ADDENDUM No. 1

Project Name:	Owner: City of Dexter Project Name: Dexter City Hall Renovations	Addendum No: One (1)
Project Number:	21-113	Issue Date: January 21, 2022
Project Location:	3515 Broad St. Dexter, Michigan 48130

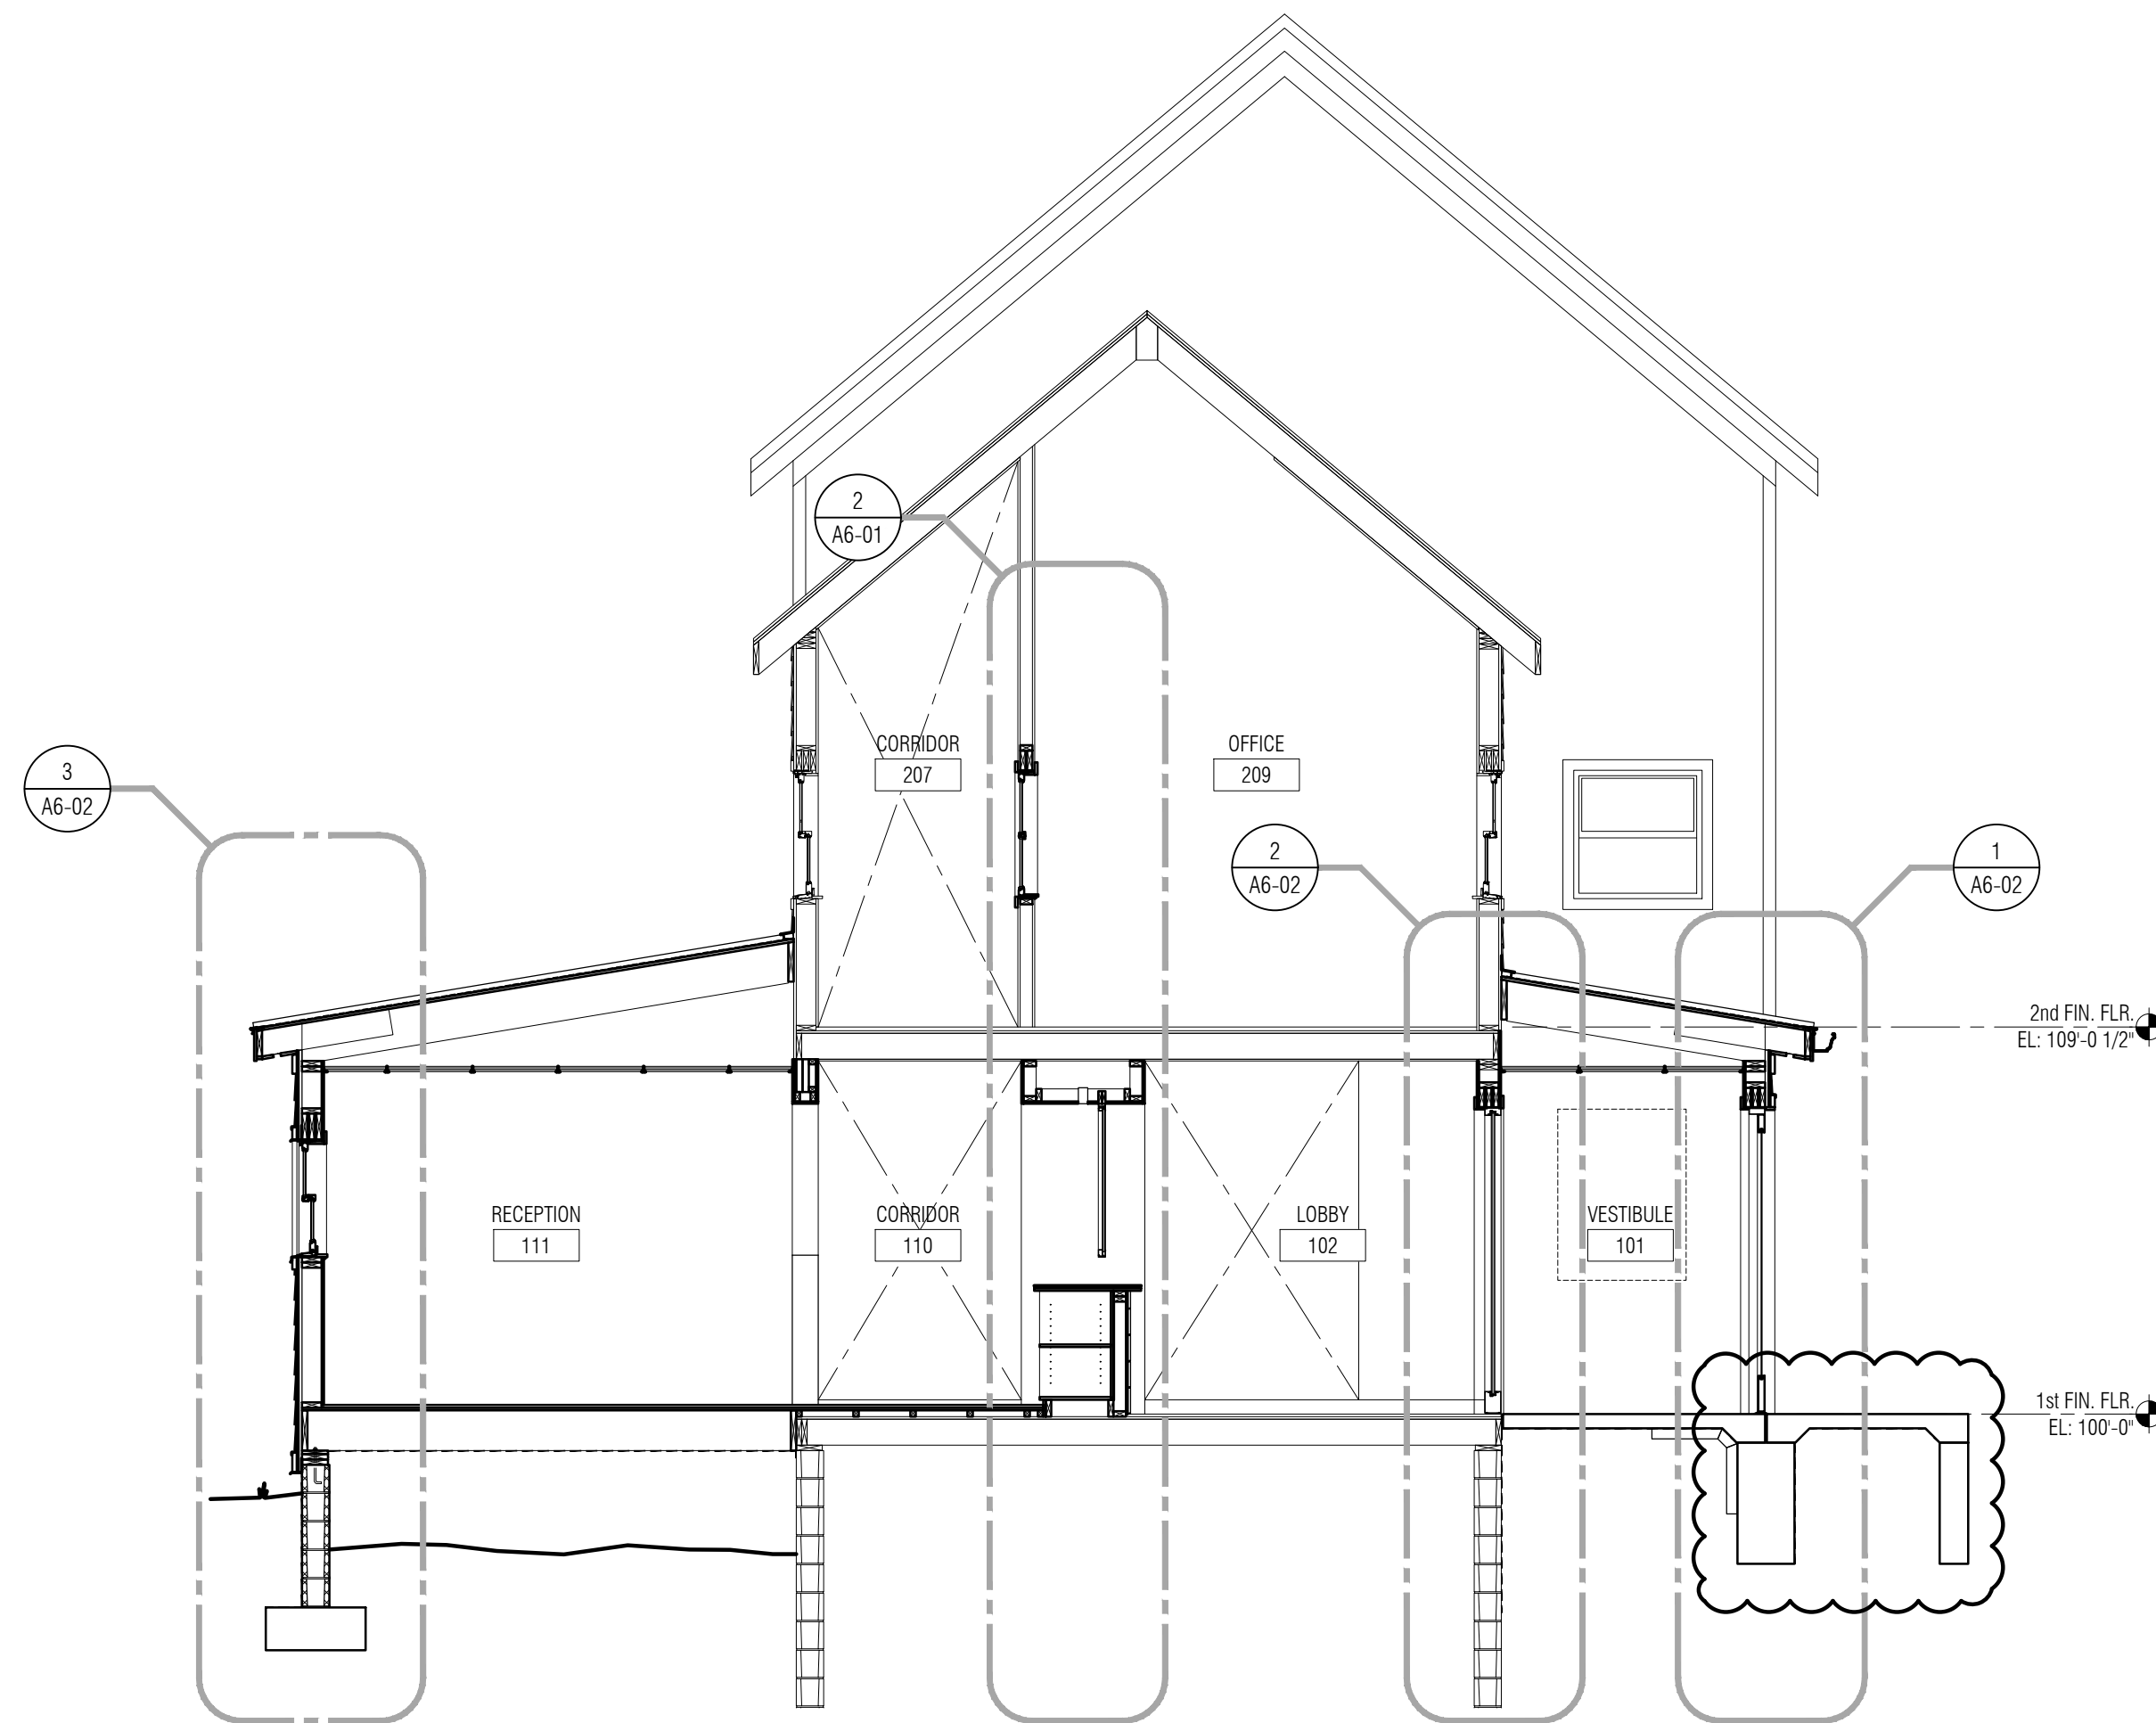
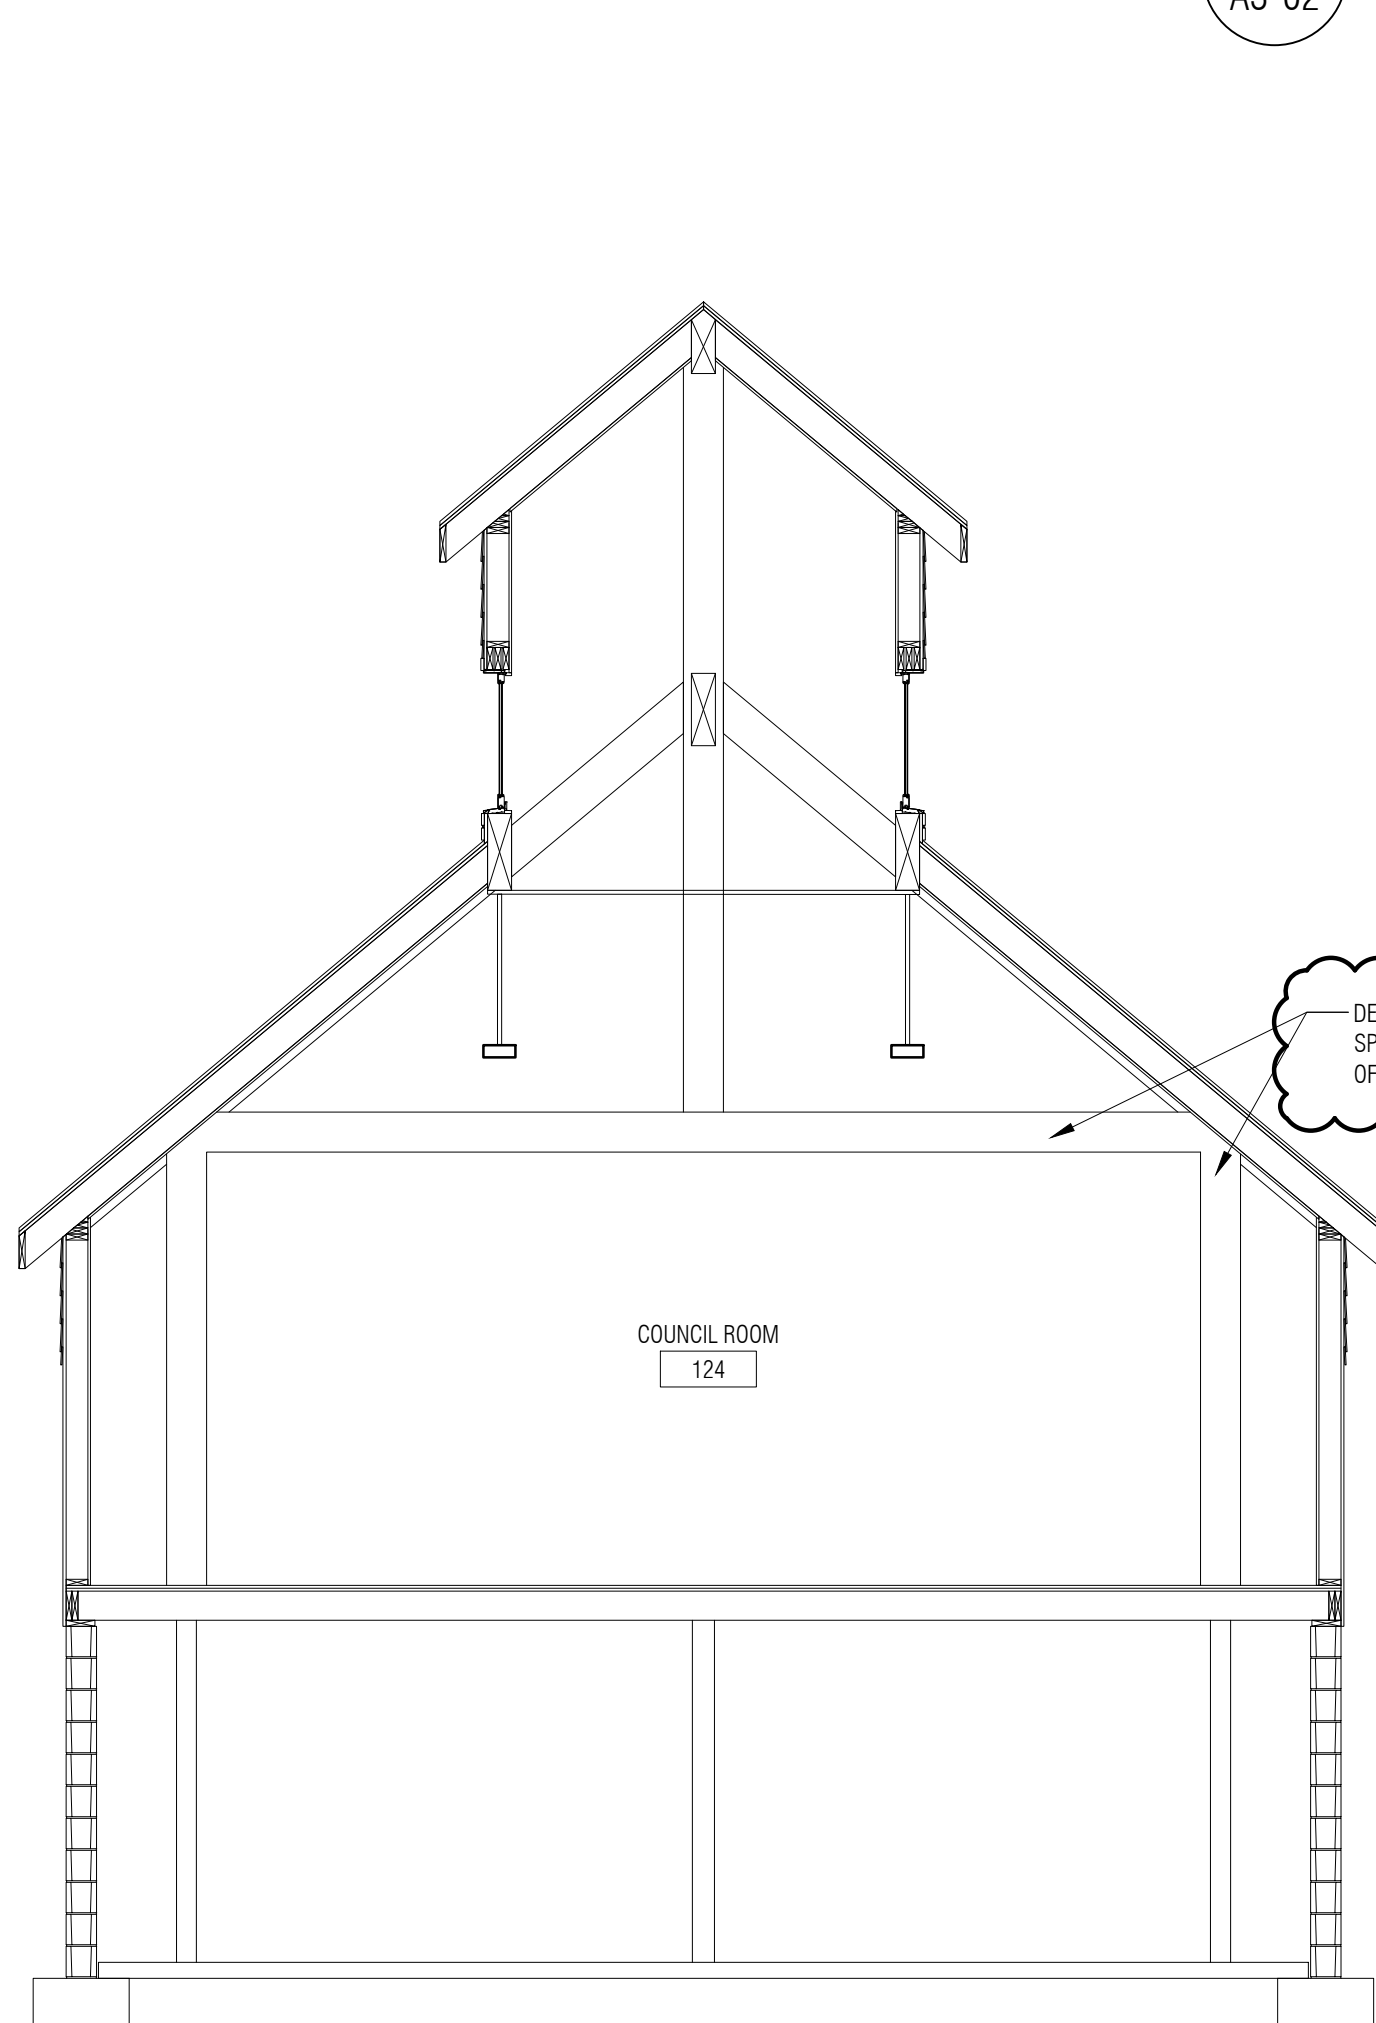
- ITEM A21** A5-10 Building Sections (Revised & Re-Issued)
- A. Filled out missing tag information on section 5.
 - B. Extended section 4 to show supported slab in front of vestibule.

- C. Updated note on section 3 to refer to deduct alternate #6, rather than add alternate # 3.
 - D. Removed door from section 2.
 - E. Now showing drain tile on both sides of elevator pit on section 2.

- F. Updated stair railing to show tension cable system, rather than vertical bars, on section 1.
 - G. Added detail of hoteling area per updated plan changes.
